Application No. 10/565,676
Reply to Office Action of June 5, 2007

Amendments to the Drawings:

REMARKS

Fig. 2

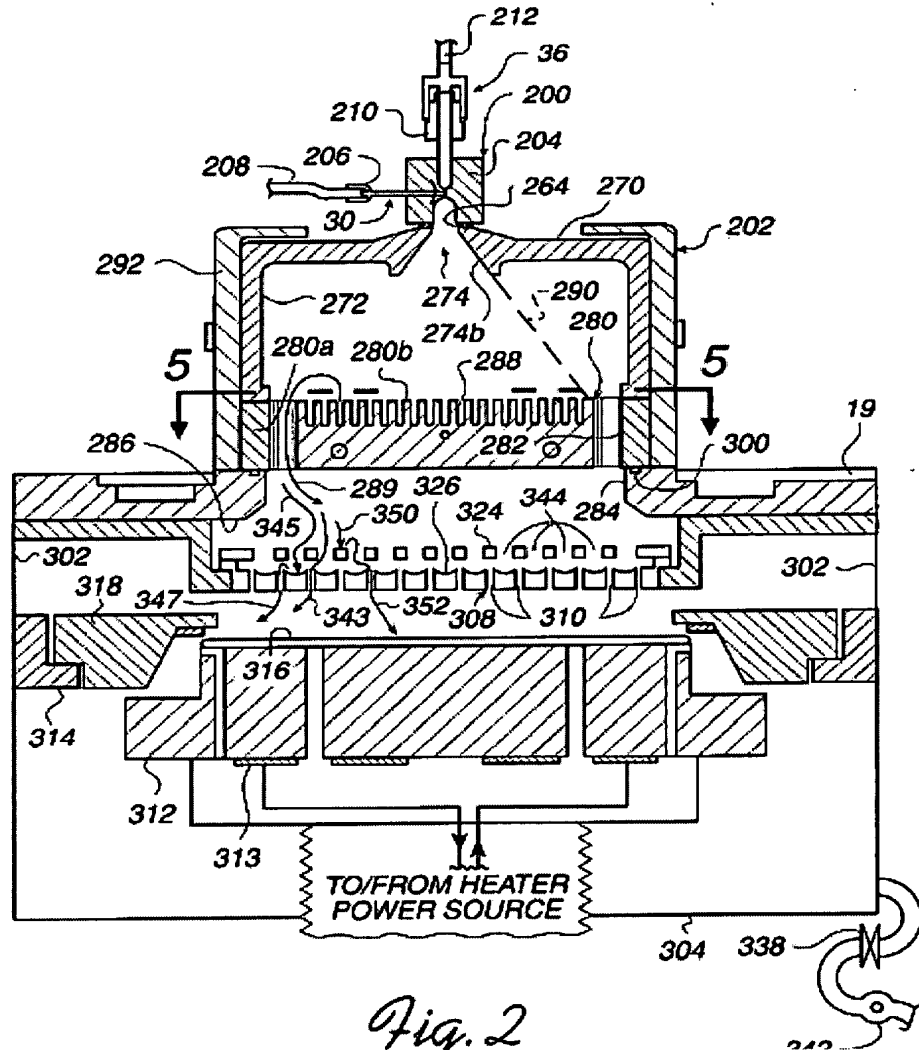
Schmitt et al disclose an apparatus for vaporization of deposition material in a deposition process system. The vaporizer 12 of Schmitt et al is shown in Fig. 2. The Office Action asserted on page 4 that a space below hot plate 280 and shower head 308, including shadow plate 324, corresponds to a draining unit. Figure 2 of Schmitt et al is reproduced below for the sake of convenience.

Specifically, Schmitt et al describe at col. 9, lines 13-50, that the nature and function of the shadow plate 324, associated in the Office Action with a draining unit, is to prevent the flow of liquid material to the wafer surface by capturing and secondarily vaporizing such liquid. Schmitt et al's space below hot plate 280 and shower head 308, including shadow plate 324 would more closely correspond to a source gas diffusion space than a draining unit.

Hence, the Office Action has not made its requiring showing in Schmitt et al of each and every element of Claim 1 in as complete detail as is contained in Claim 1, as the elements associated in the Office Action with a draining unit is not properly a draining unit. Thus, Claim 1 is not anticipated by Schmitt et al.
